ADDENDUM NO. 3

PROJECT NAME: Transformers Replacement Project
UNL PROJECT NUMBER: C951P057

CONSULTANT: Morrissey Engineering, Inc.
ADDRESS: 4940 North 118TH St., Omaha, NE 68164

DATE OF ISSUANCE: 3 November, 2011
DATE OF BID OPENING: 9 November, 2011

sketch **e2.1**

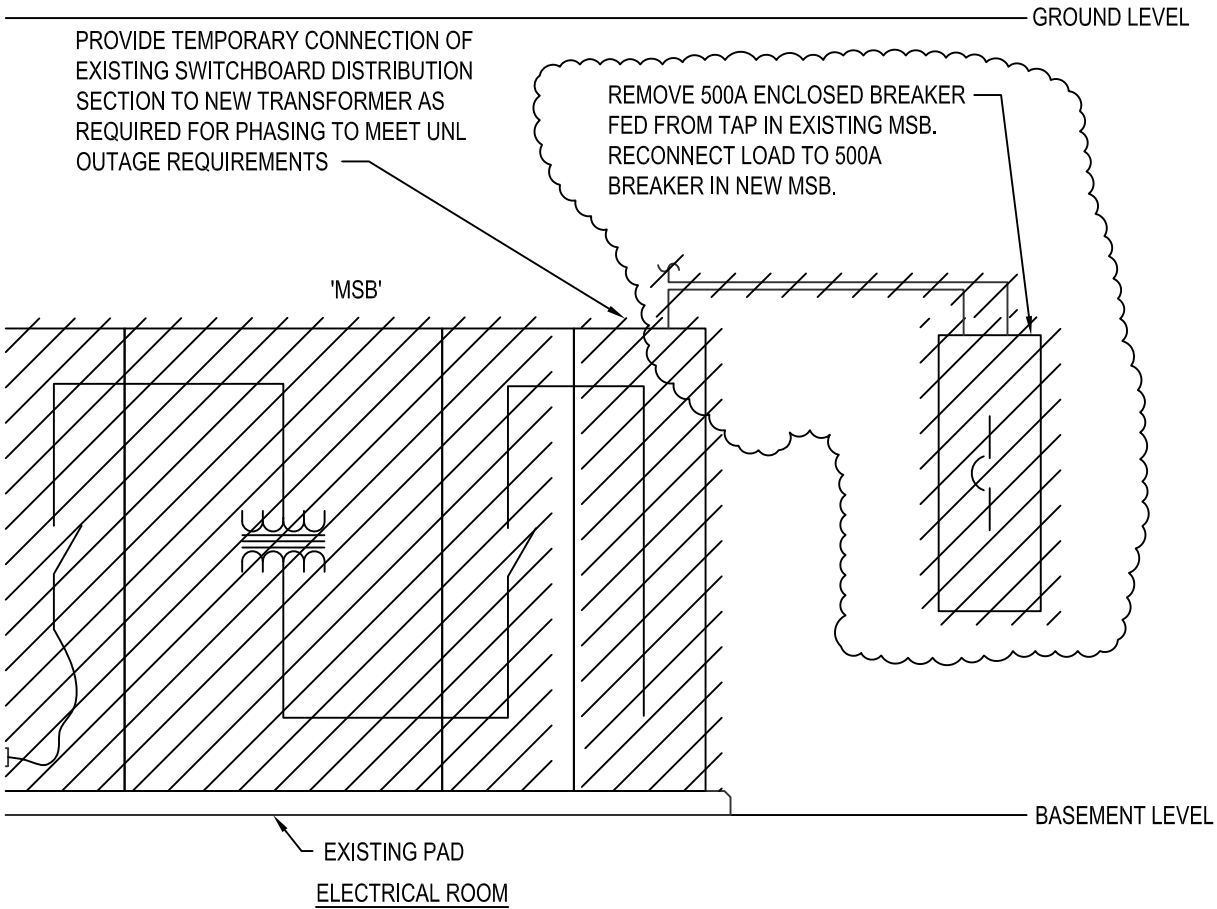
1. General sheet note requirement to turn scrap copper is removed.
2. On 'Interior Plan – Demolition', 500A enclosed breaker location is shown on North wall of existing electrical room. See attached sketch e2.1
3. On 'Site Plan', revise flag note #3 to say "Provide cast-in-place manhole 'W.0-14.4' around existing ductbank beneath street. Break and remove ductbank concrete encasement in manhole. Ductbank conduit removal in manhole will be provided by UNL. Do not disrupt other existing underground utilities. Provide structural engineered manhole per structural plans sheet SA.1"

sketch e3.1

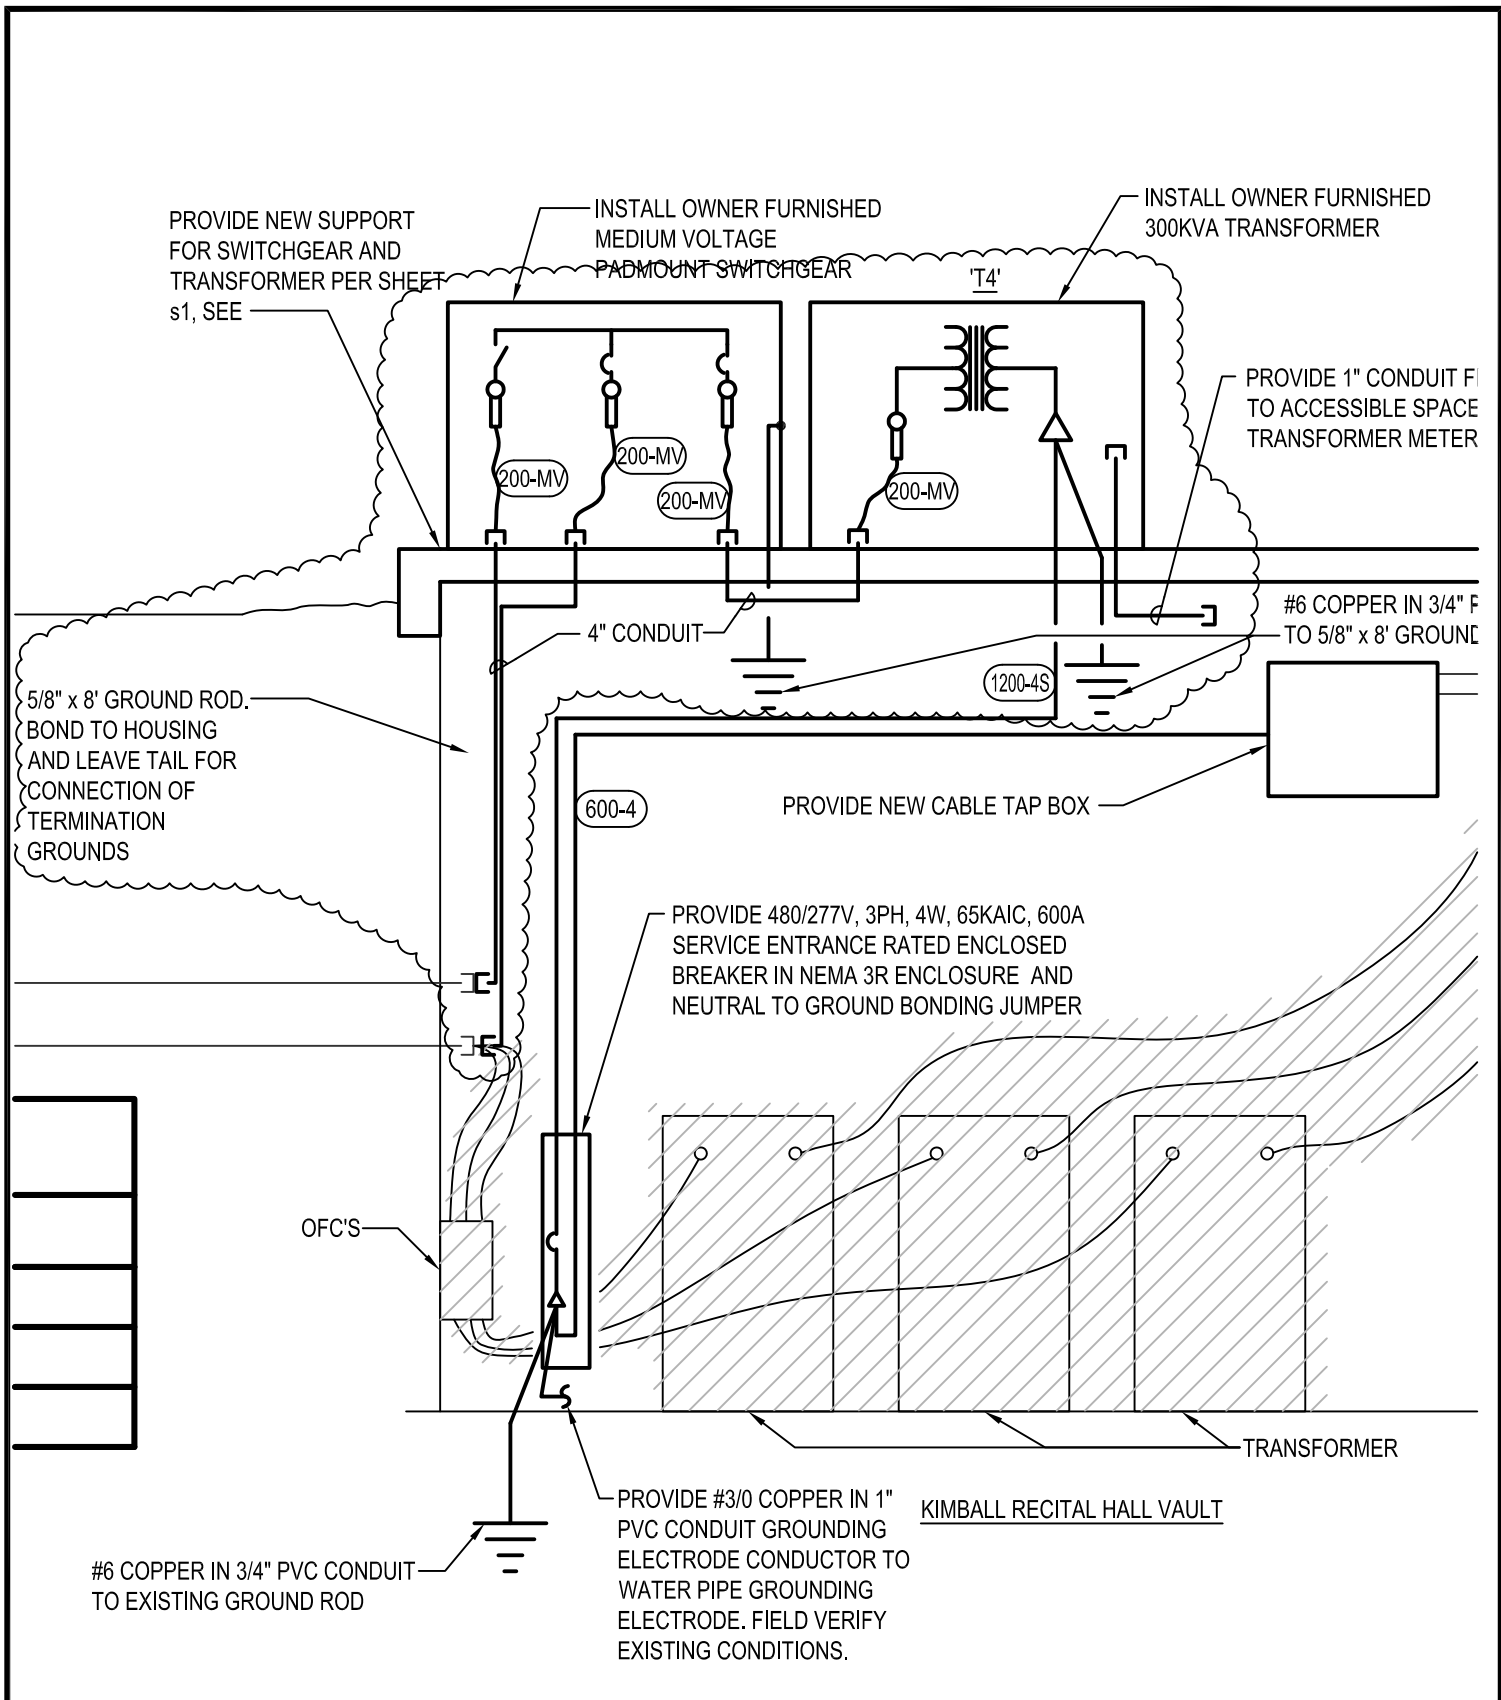
1. On 'Riser Diagram – Demolition', 500a enclosed breaker served from tap in existing 'MSB' shall be removed. Line side feeder and the portion of load side circuiting between breaker and junction box above 'MSB' shall be removed. Load shall be reconnected to new 500A breaker in new 'MSB'. See attached sketch e3.1.
2. On 'Riser Diagram – New', splices required to reconnect loads to new 'MSB' shall be crimped.

e4.2

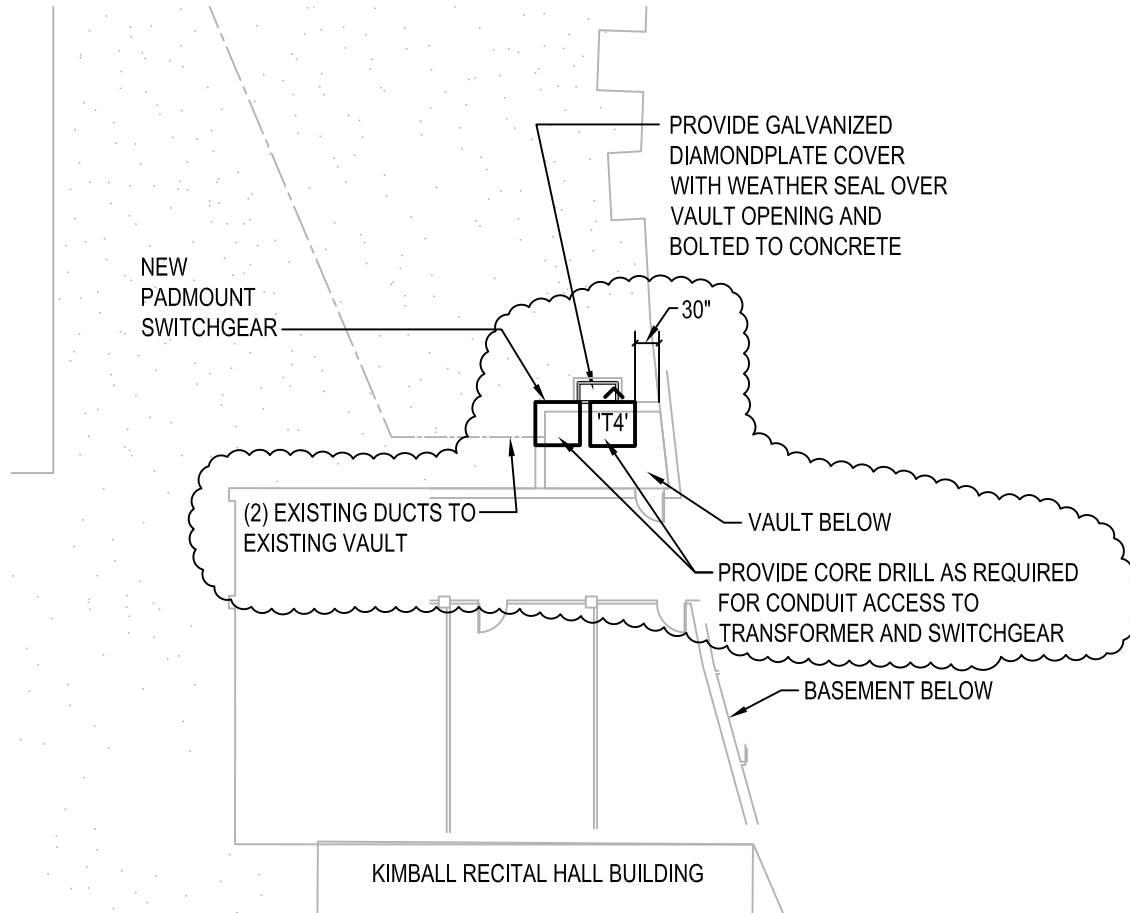
1. General sheet note requirement to turn over bus duct and other scrap copper is removed.
2. On 'Site Plan' revise layout to reflect equipment fitting over footprint of existing vault. See attached sketch e4.2.
